O'Hare Modernization Program
October 2003

Response to ALP Comments

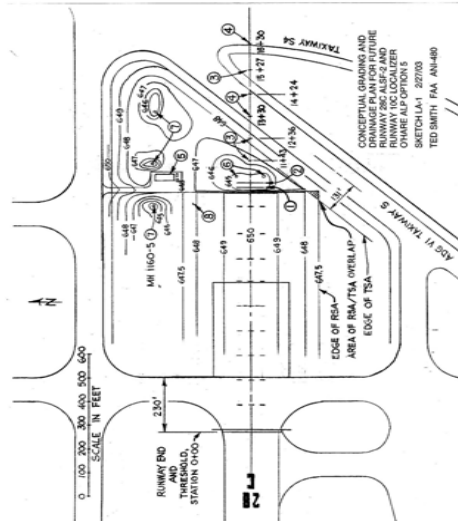
b.	<u>Runway 28C ALSF-2 and Inner Marker and Runway 10C Localizer:</u>	Low approach light plane profile and semi-flush lights will be required. Provisional light bar stationing depicted on ALP to be refined during engineering design. Inner marker siting will be non-standard and may require a NCP waiver. Currently shown as 205' offset from centerline. See general comment under B-39 for localizer resolution.

i)	The FAA anticipates that semi-flush steady-burning and flashing lights will be installed at nominal stations 13+00, 14+00, 16+00, 21+00, and 22+00.	(See general comment under B-39b)
ii)	The approach light plane must have a very low profile. In crossing Runway 4R-22L and Taxiways "S" and "S4", the ALSF-2 approach light plane will have to stay very close to runway and taxiway existing grade.	(See general comment under B-39b)
iii)	The Runway 10C Localizer array location as proposed is a high object, and is prohibited from penetrating the low-profile Runway 28C ALSF-2 approach light plane.	(See general comment under B-39b)

Ref. No.	Comment	Response
iv)	<p>The array is 6.8 feet high from the top of the foundation (at finished grade) to the top of the radome. With customary infield grading, the array would penetrate the level approach light plane of a low-profile ALSF-2. FAA Order 6850.2a, Visual Guidance Lighting Systems prohibits any penetration of the approach light plane on CAT-II or CAT-III approaches. The antenna array will be at least a 14-Element Log Periodic Dipole Array. While such arrays do behave as frangible objects when struck, there would nevertheless be considerable mass protruding above the approach light plane. Corrective action will be required to meet FAA standards. In view of the above, the following two design options should be considered:</p>	(See general comment under B-39b)
